Re: Written Comments on the Draft GHG Air Permit No. 0310583-002-AC (PSD-426A) Jacksonville Lime, LLC Proposed Lime Manufacturing Facility Facility ID No. 0310583
Jacksonville, Duval County, Florida

<u>Submitted Written Comments on the Draft GHG Air Permit No. 0310583-002-AC (PSD-FL-426A) Jacksonville Lime, LLC Lime Manufacturing Facility</u> Jacksonville, Duval County, Florida

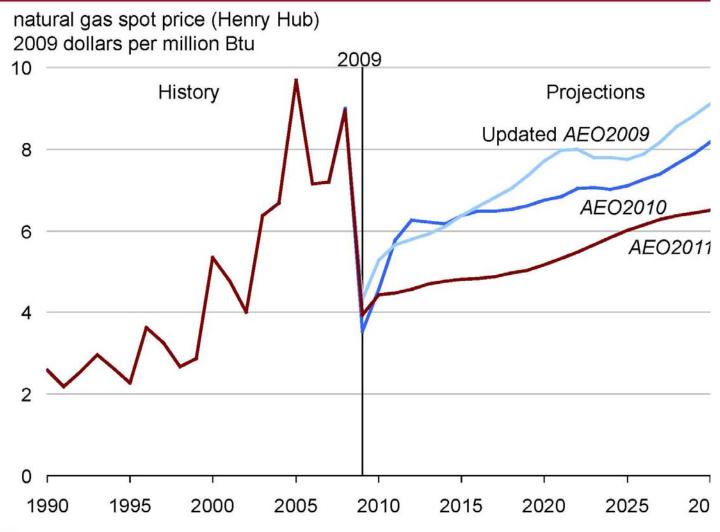
The data provided by the applicant presents estimated GHG emissions only from the Maerz PFR Shaft kilns. In their PSD application and BACT analysis, the applicant frequently references the performance of the kilns at the Winchester, Va. site, which we understand to be the Maerz PFR kilns. Yet, in the submitted GHG Permit application for the Keystone site in Jacksonville, it appears the applicant has selected another manufacturer and kiln type, the Cimprogetti "Cim-Reversy TSR" kiln. The change in kiln supplier creates questions as to whether the current BACT Analysis in the GHG Permit Submission is, in fact, credible.

The applicant should provide information from both kiln manufacturers quantifying the impact of any design and operational changes on GHG emissions and any criteria pollutant. Additionally, the applicant should reconcile any differences between the approved PSD Permit for criteria pollutants and the GHG permit submission.
